**REQUEST**

Current Zoning: IC-1 (Institutional Campus-1), CG (General Commercial), N1-A (Neighborhood 1-A)  
 Proposed Zoning: N2-B(CD) (Neighborhood 2-B, Conditional)

**SUMMARY OF PETITION**

## PLANNING STAFF REVIEW

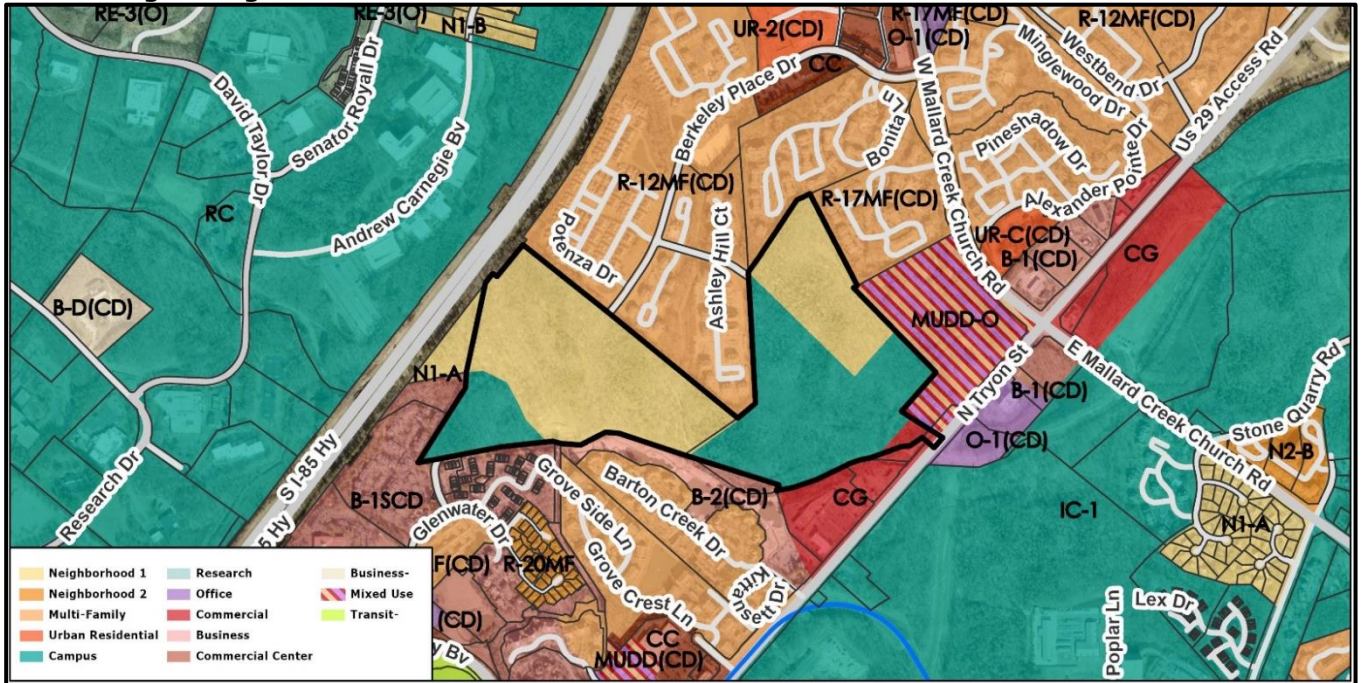
1. Site plan shows tree save within the dedicated ROW and below the 30-foot width. Tree save cannot be within the ROW.
2. Please match the number of units shown on the plan to the number of units proposed in the notes.
3. Commit to a minimum dimension for the covered front stoop.
